Access Compliance Report

Public Rights-of-Way

Intersection ID: 8535	Main Street: BROOKSHIRE_BV	Cross Street: NELSON_AV	Location: S
ADA ID: 5AE42C637ABD	Ramp Type: Perp	Initial Pass/Fail: Fail	Overall Compliance: No
		Severity Score: 12.5

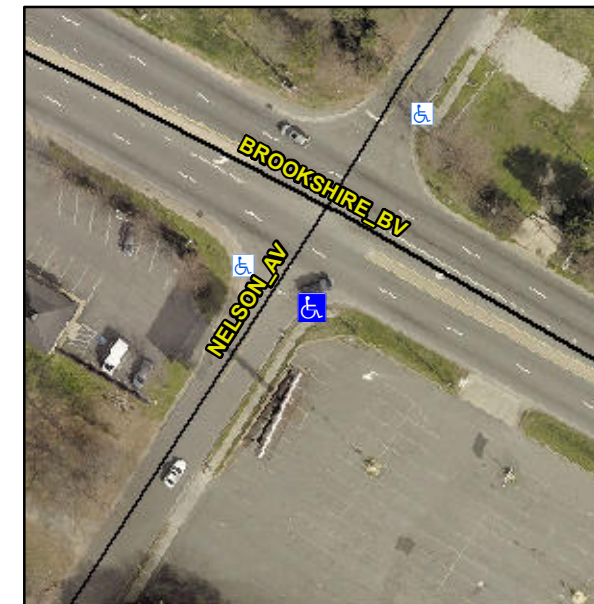
Not Found, R304.2.2

Compliance	Description	Data	Compliance	Description	Data
N/A	Ramp Length (in)	83.0	No	Ramp Slope (%)	9.2
Yes	Ramp Width (in)	48.0	Yes	Ramp XSlope (%)	0.9
N/A	Flare Type LT	N/A	N/A	Flare Type RT	N/A
N/A	Flare Slope LT (%)	N/A	N/A	Flare Slope RT (%)	N/A
N/A	Flare Traversable LT?	N/A	N/A	Flare Traversable RT?	N/A
N/A	Landing Length (in)	N/A	N/A	DWS Provided?	N/A
N/A	Landing Width (in)	N/A	N/A	DWS Contrast?	N/A
N/A	Landing Slope (%)	N/A	N/A	DWS Length (in)	N/A
N/A	Landing X Slope (%)	N/A	N/A	DWS Full Width?	N/A
N/A	Landing Curb? (Y/N)	N/A	N/A	DWS Offset (in)	N/A
N/A	Shared Landing?	N/A			
N/A	Gutter Ponding?	N/A	N/A	Gutter Slope (%)	N/A
N/A	Gutter Lip Ht (in)	N/A	N/A	Gutter X Slope (%)	N/A
N/A	Painted X Walk1?	No	N/A	Painted X Walk2?	N/A
	X Walk 1 Direction	To NW		X Walk 2 Direction	N/A
N/A	X Walk 1 Width (in)	N/A	N/A	X Walk 2 Width (in)	N/A
	X Walk 1 Slope (%)	7.1		X Walk 2 Slope (%)	N/A
	X Walk 1 X Slope (%)	2.2		X Walk 2 X Slope (%)	N/A

Remove & Replace Entire Ramp.
